Addendum No. 2
March 15, 2018

Project: **Lincoln High School – Window Replacement & Miscellaneous Renovations 2018 PD #3150**
Sioux Falls, South Dakota
Project No.: 2763

Architect: Architecture Incorporated

12) DRAWING SHEET 4.40 – ENLARGED RESTROOM FLOOR PLANS

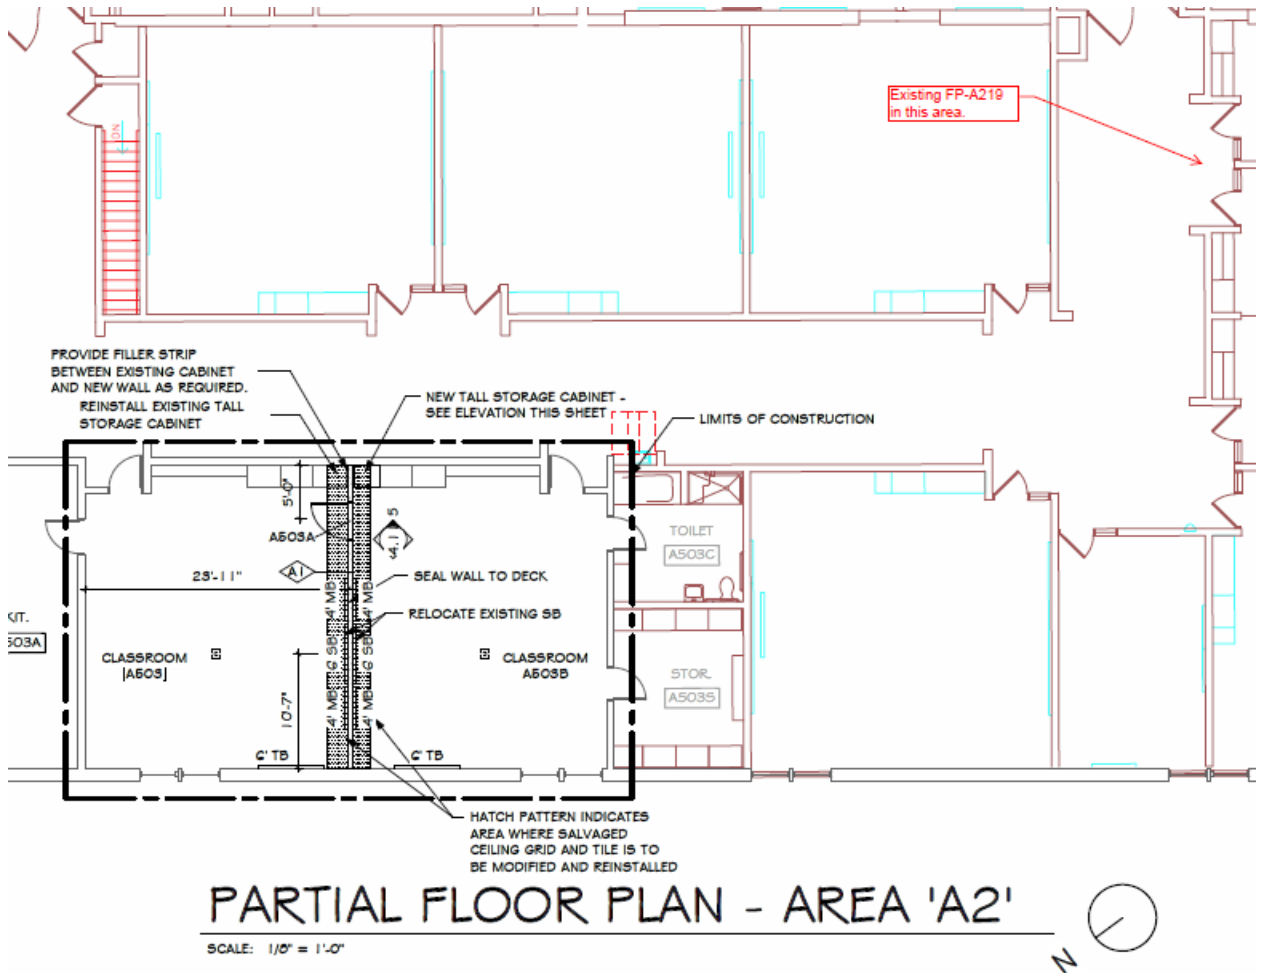
- a) Reference Enlarged Toilet Room plan – provide 2” cmu soap enclosure as required to conceal existing column at west wall of Room B111C.
- b) Reference Toilet Accessory Schedule – Omit ALL occurrences of Note 6 in the Toilet Accessory Schedule.

- i) Toilet accessory Item E should be keynoted with Note 8.
 - ii) Toilet accessory Items H & M should be keynoted with Note 5.
 - iii) Toilet accessory Items A, B, C, D, F, J & R shall not have any keynotes associated with them.
- c) Provide fire rated acoustical panel ceiling enclosures above mechanical, electrical and plumbing items that penetrate the rated ceilings at rooms B111A, B111B and B111C.

PROJECT NO. 117136	SHEET
DATE 3-15-18	R8. 30
DRAWN BY NJH	1 OF 1

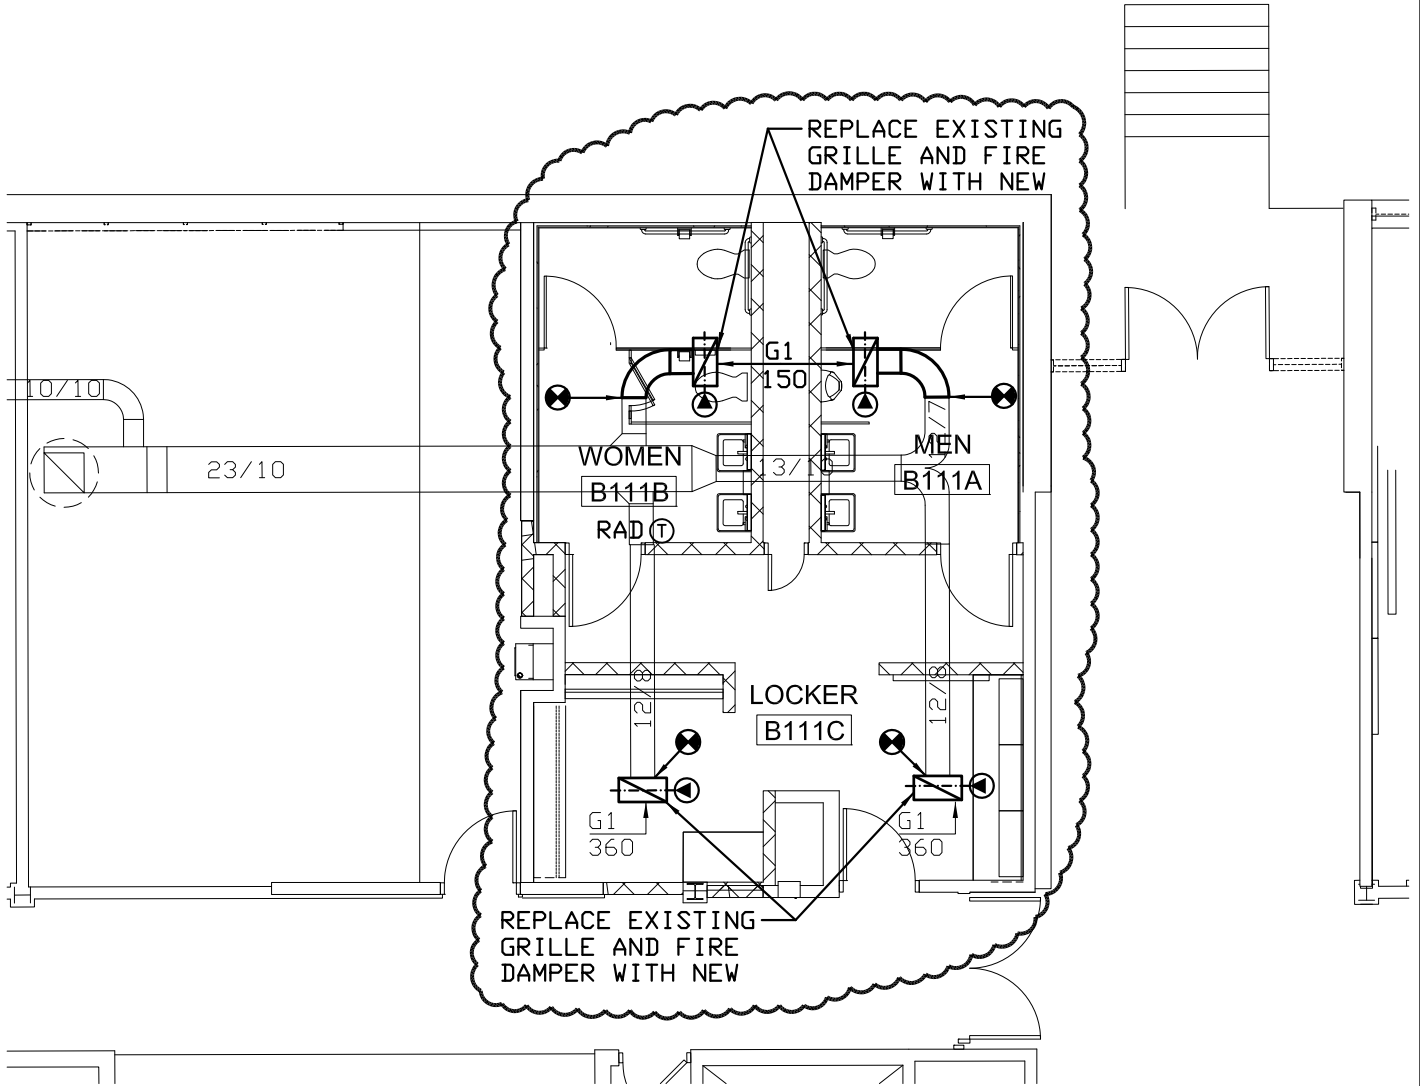
- a) Replace exhaust grilles to accommodate new ceiling and provide fire dampers. Refer to revised drawing sheet R8.30, dated 03-15-18 attached to the end of this addendum.
- b) Area “A2”: Disconnect and re-connect FP-A112 (being relocated and re-named to FP-A503), extend/reroute existing raceways and conductors as required.
- c) Area “A2”: Provide connection to FP-A211, connect to the 277V branch circuit serving existing FP-A219 (see below for location).
